Project: 1648 - FW NW Community Center
 8735 Blue Mound Road
 Fort Worth, Texas 76137

Prime Contract Potential Change Order #015: PR #9 Sanitary Sewer: CoFW TP/W Changes

CE #016 - PR #9 Sanitary Sewer
 PR #9 Revision Scope Includes:

WASTEWATER PLAN SHEET 2 OF 3

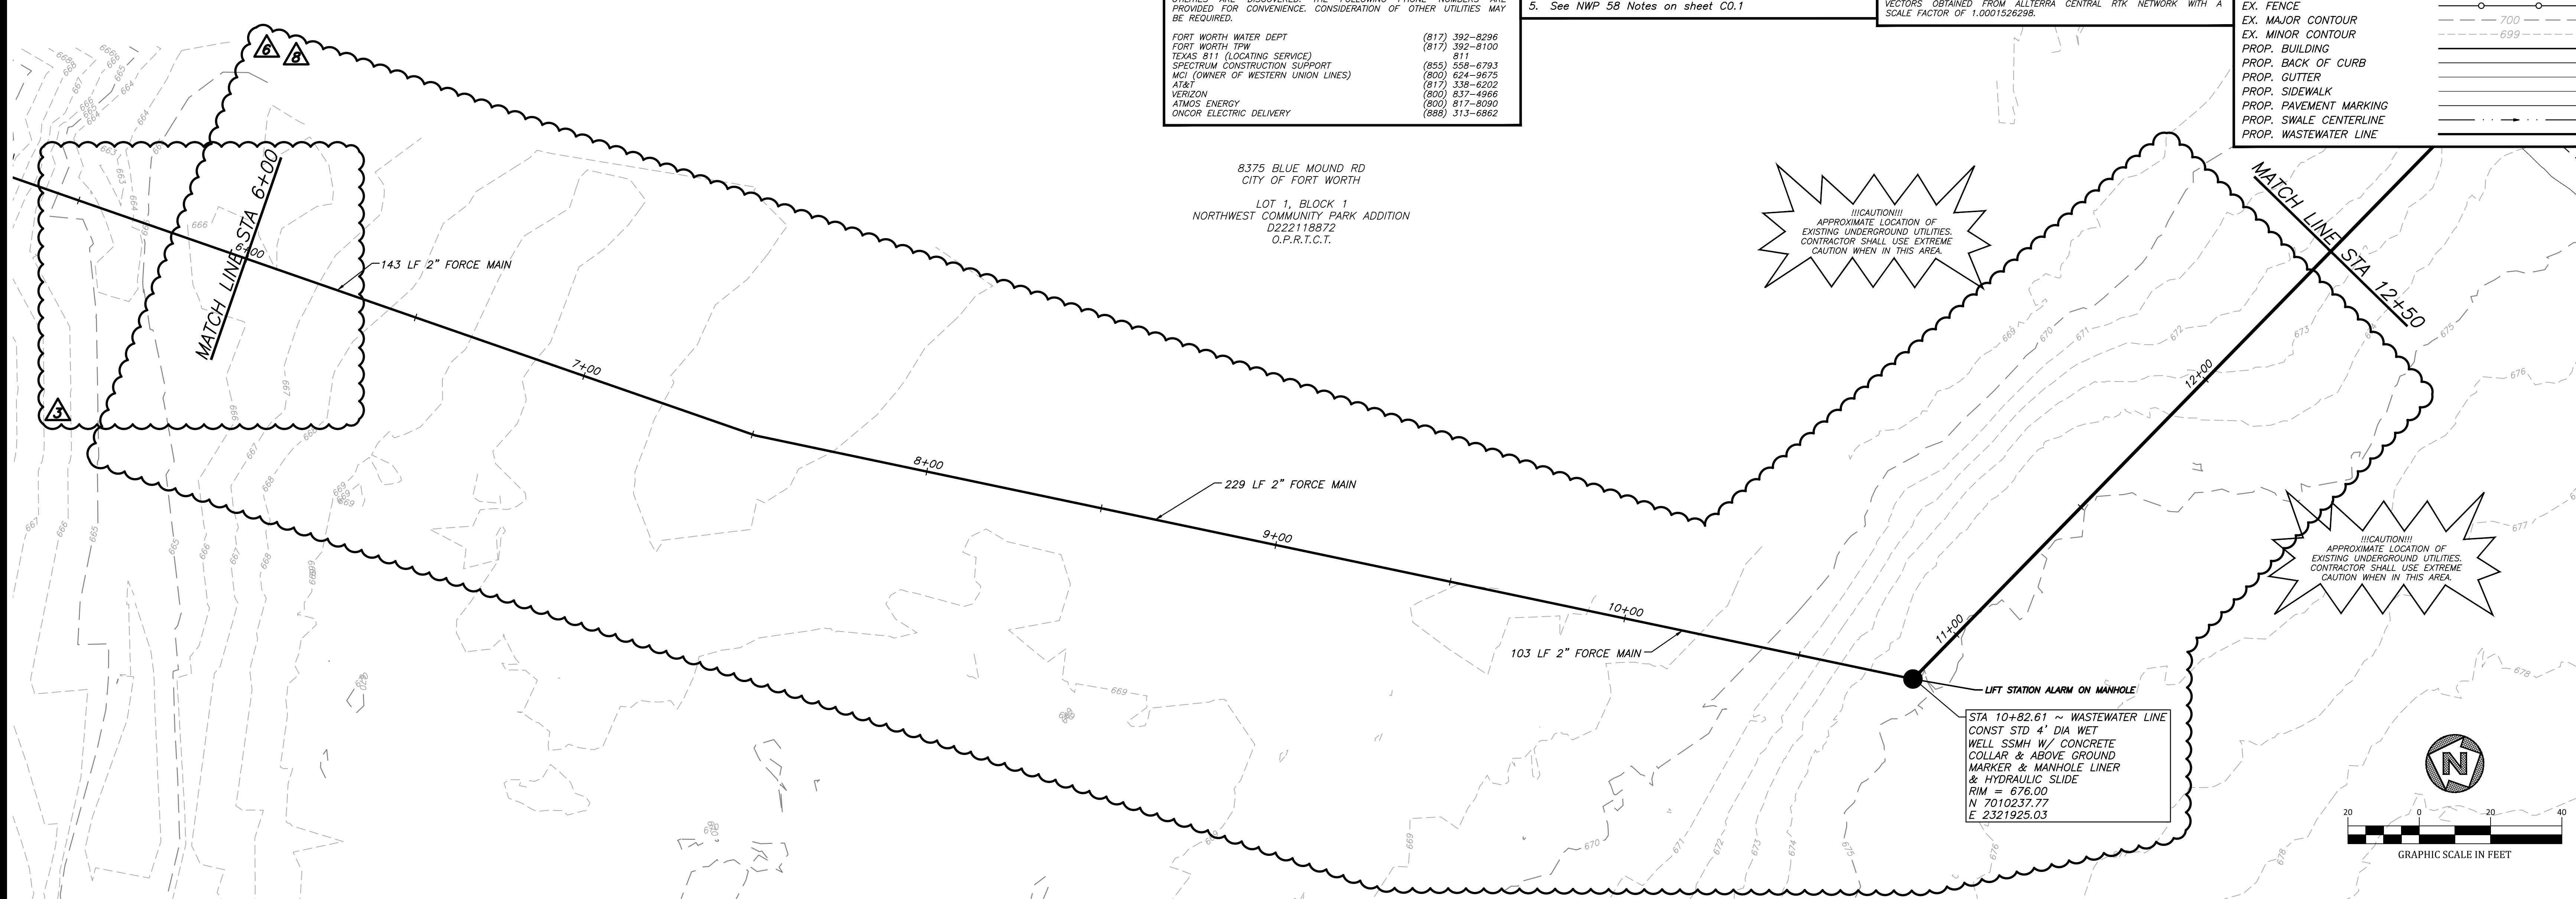
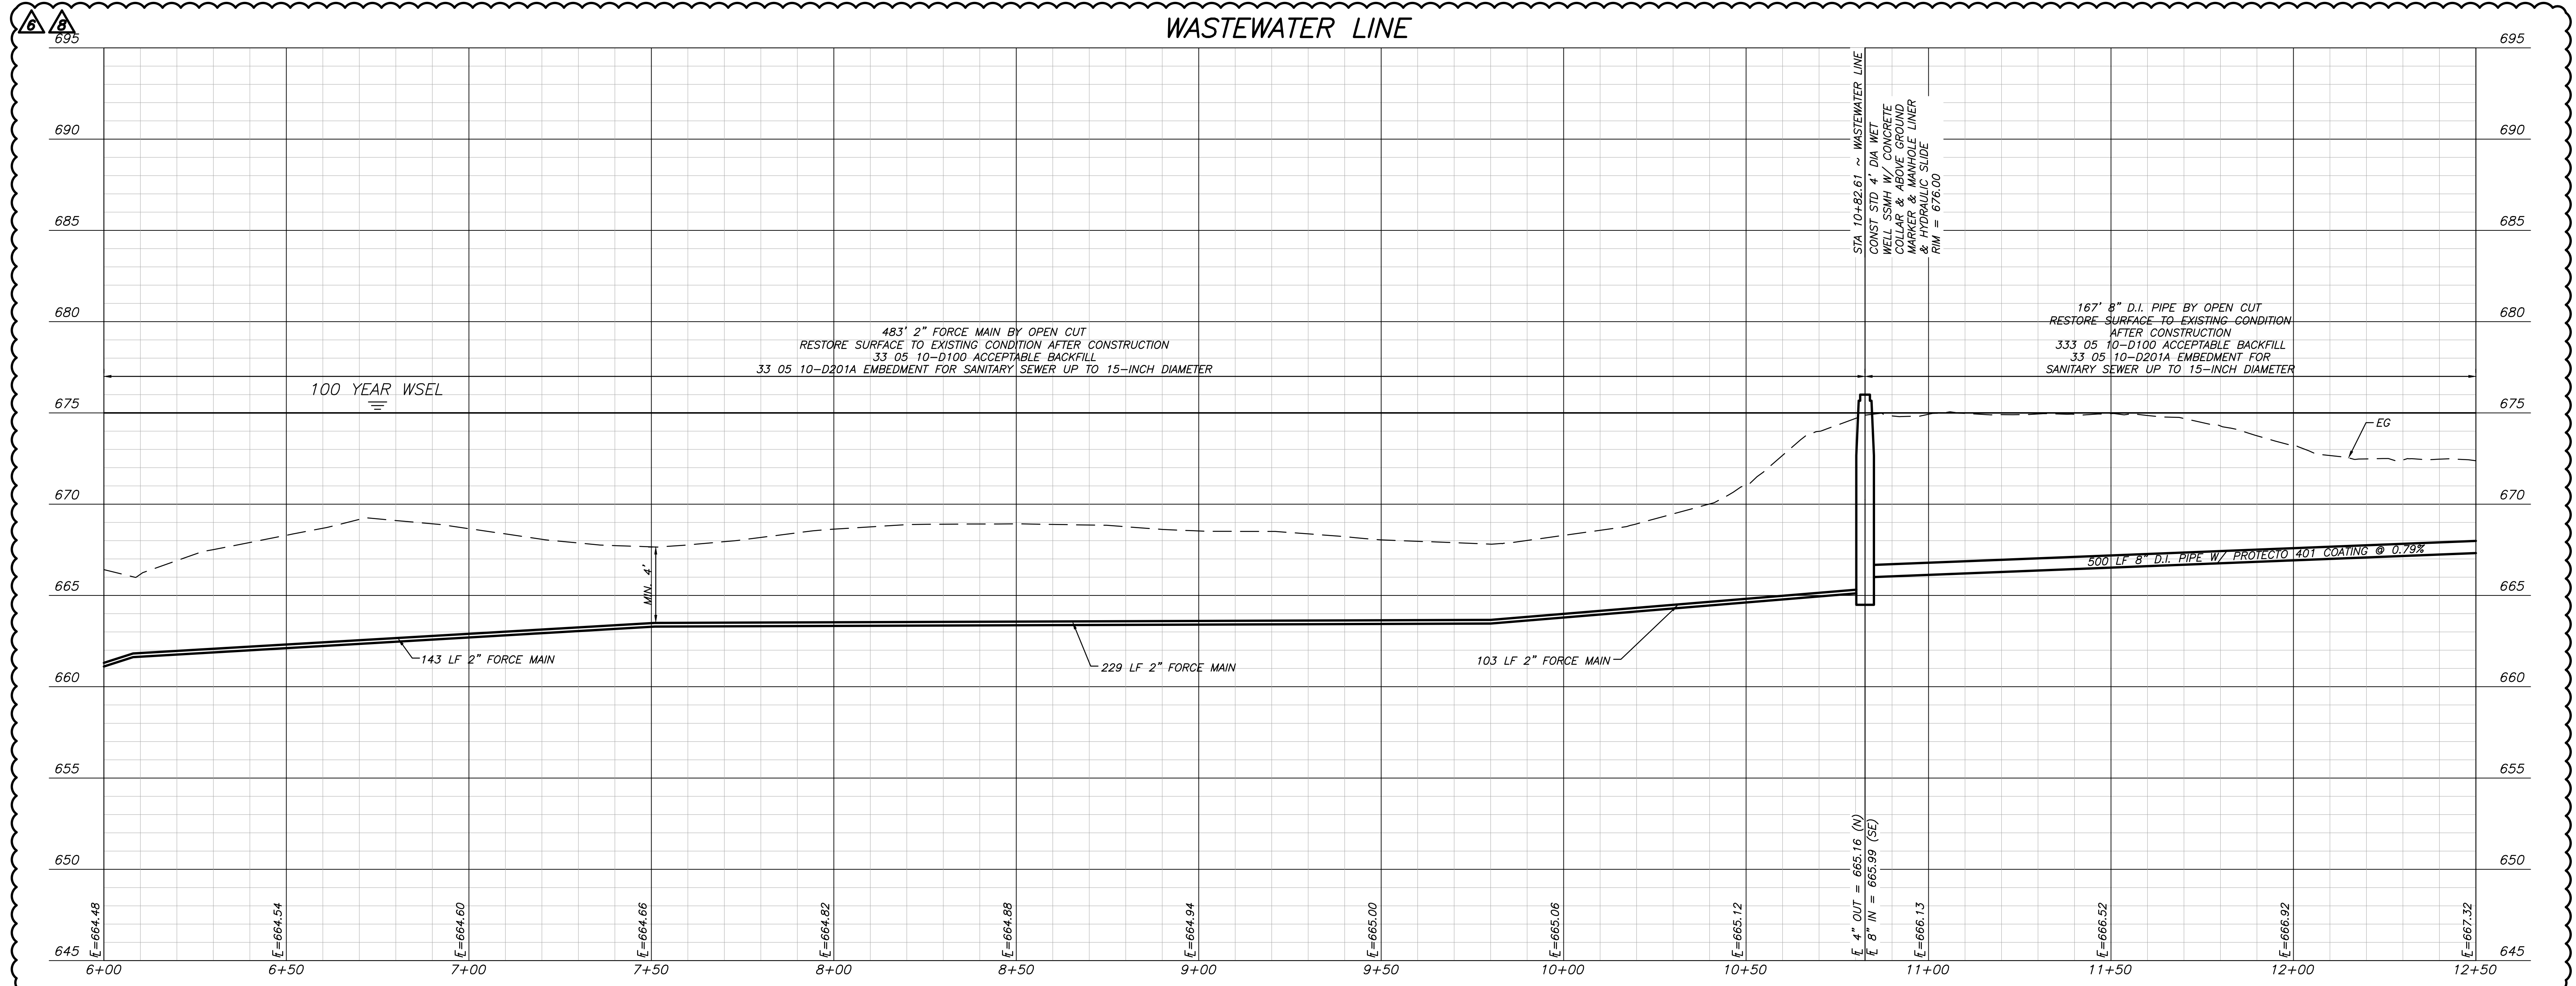
LIFT STATION ALARM ON MANHOLE
 STA 10+82.61 ~ WASTEWATER LINE
 CONST STD 4' DIA WET WELL SSMH W/ CONCRETE COLLAR & ABOVE GROUND MARKER & MANHOLE LINER & HYDRAULIC SLIDE
 RIM = 676.00
 N 7010237.77
 E 2321925.03

STA 10+82.61 ~ WASTEWATER LINE
 CONST STD 4' DIA WET WELL SSMH W/ CONCRETE COLLAR & ABOVE GROUND MARKER & MANHOLE LINER & HYDRAULIC SLIDE
 RIM = 676.00

167' 8" D.I. PIPE BY OPEN CUT
 RESTORE SURFACE TO EXISTING CONDITION AFTER CONSTRUCTION
 33 05 10-D201A ACCEPTABLE BACKFILL
 33 05 10-D201A EMBEDMENT FOR SANITARY SEWER UP TO 15-INCH DIAMETER

483' 2" FORCE MAIN BY OPEN CUT
 RESTORE SURFACE TO EXISTING CONDITION AFTER CONSTRUCTION
 33 05 10-D100 ACCEPTABLE BACKFILL
 33 05 10-D201A EMBEDMENT FOR SANITARY SEWER UP TO 15-INCH DIAMETER

1 ELECTRICAL SITE PLAN
SCALE: 1" = 40'-0"

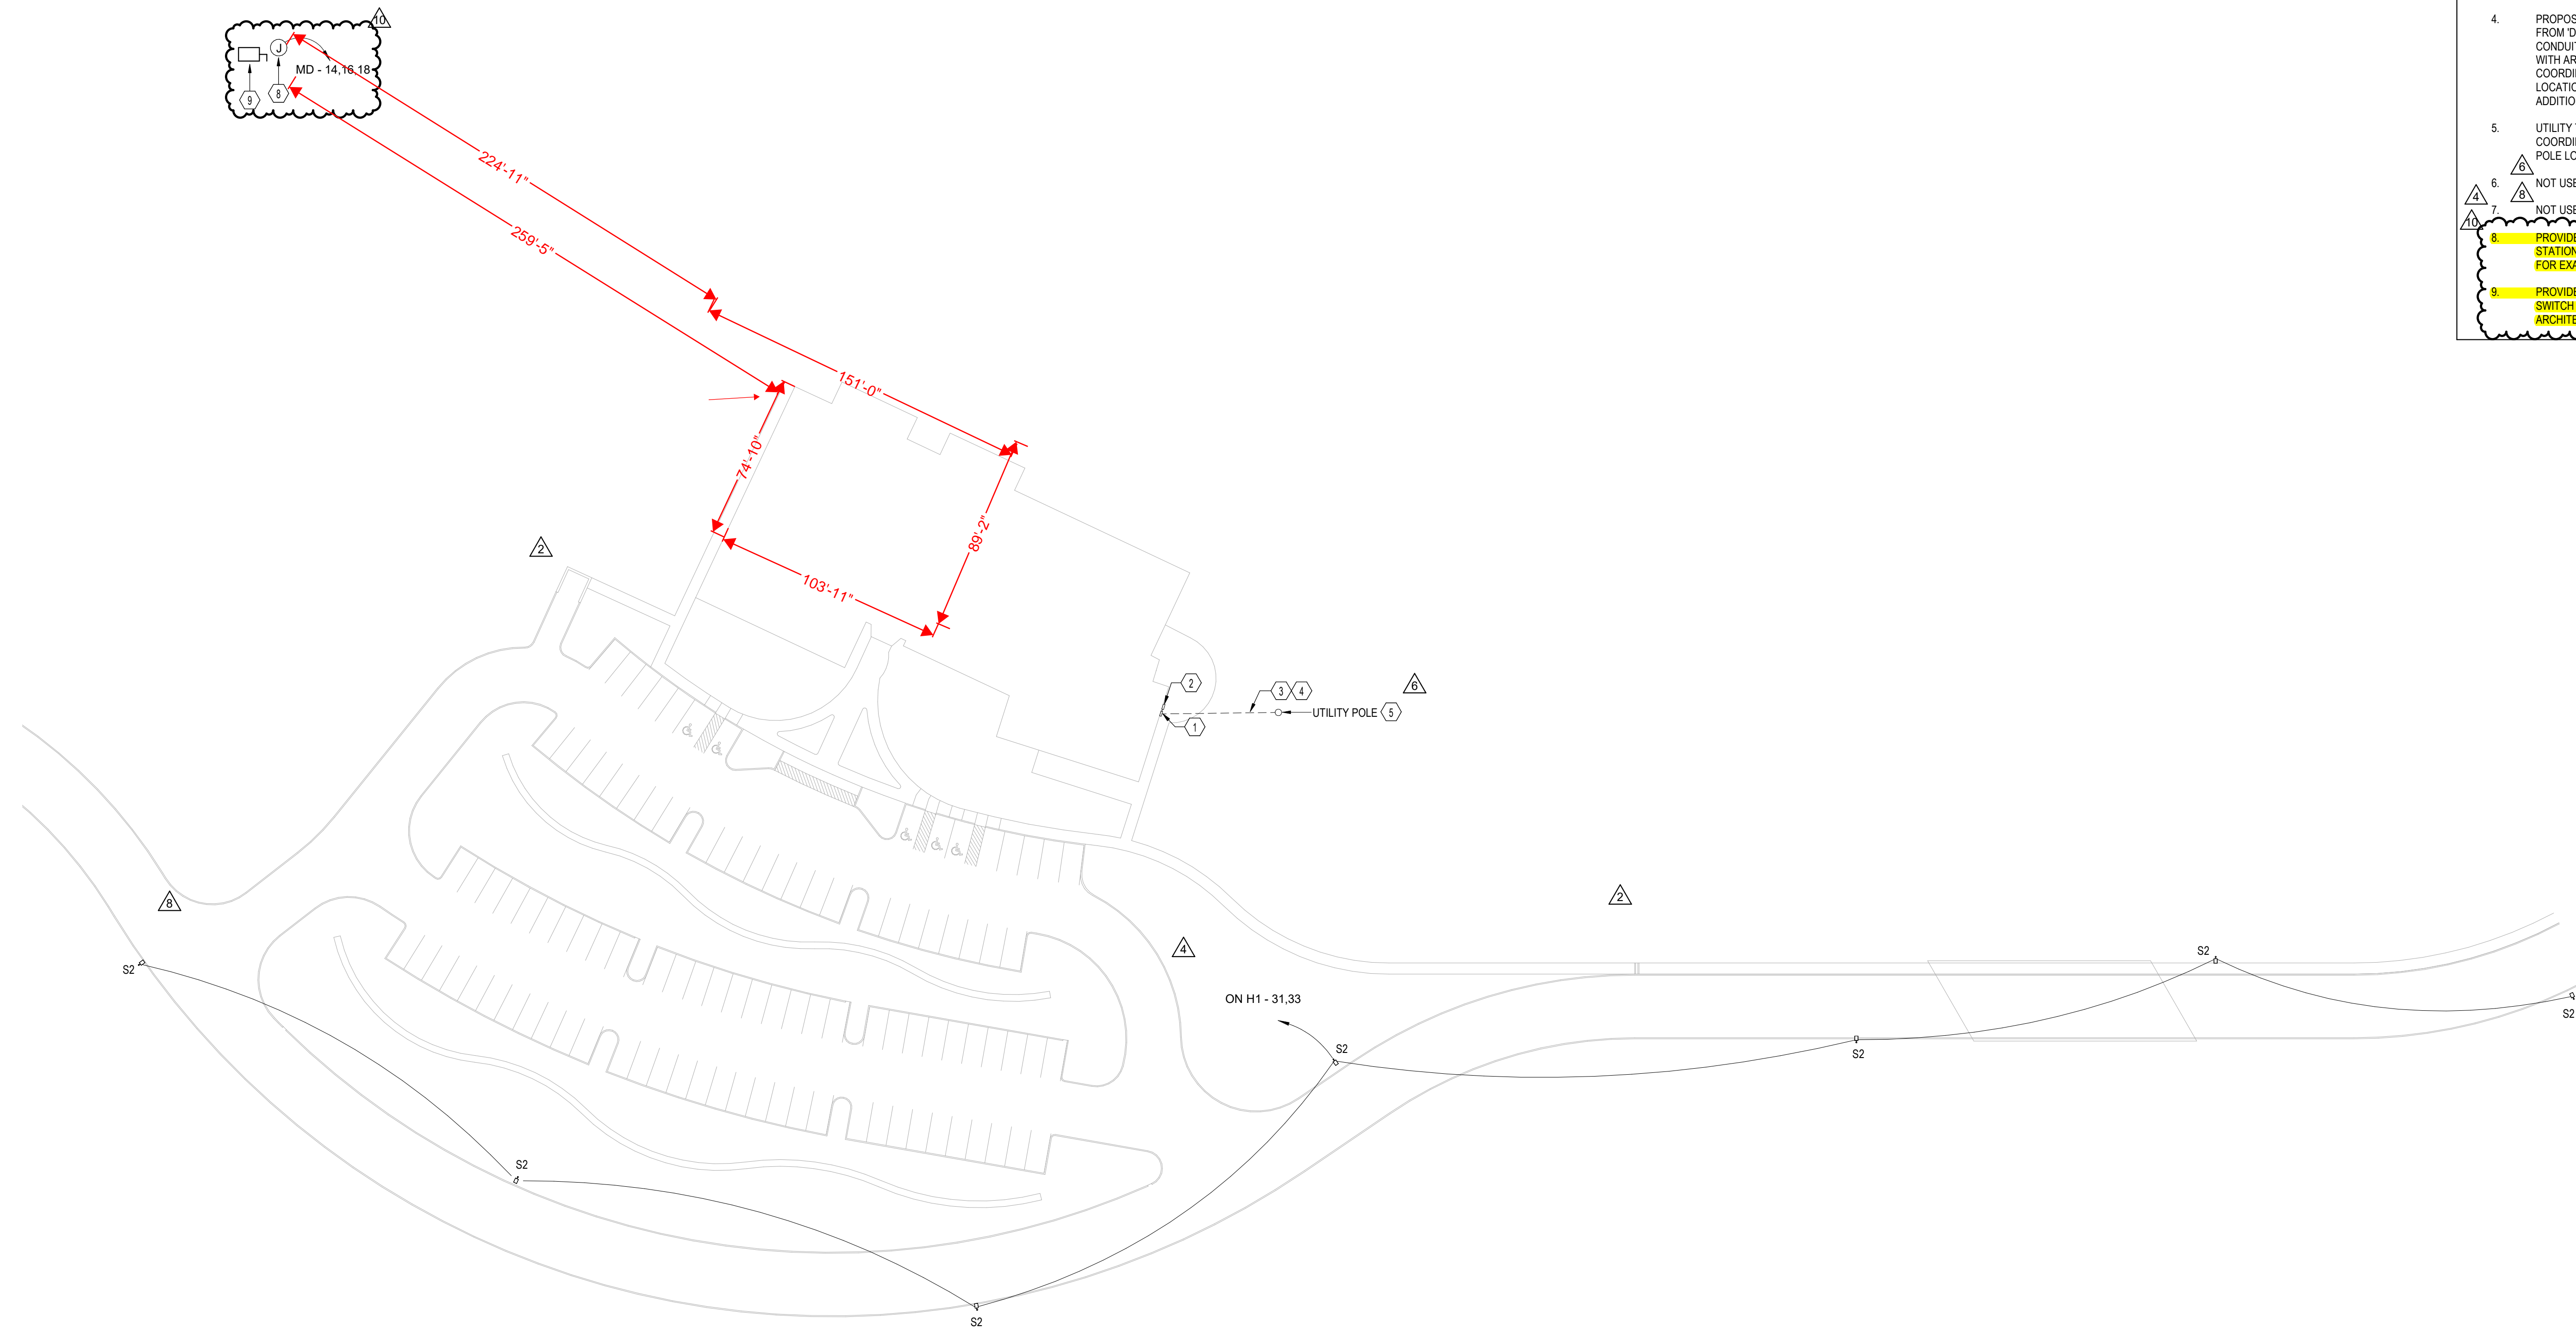
- PROVIDE DEDICATED CIRCUIT FOR POWER FOR LIFT STATION. COORDINATE WITH ARCHITECT AND CIVIL FOR EXACT LOCATION.
 - PROVIDE 600V, 30A, 3P, NEMA 3R DISCONNECT SWITCH FOR LIFT STATION. COORDINATE WITH ARCHITECT AND CIVIL FOR EXACT LOCATION.
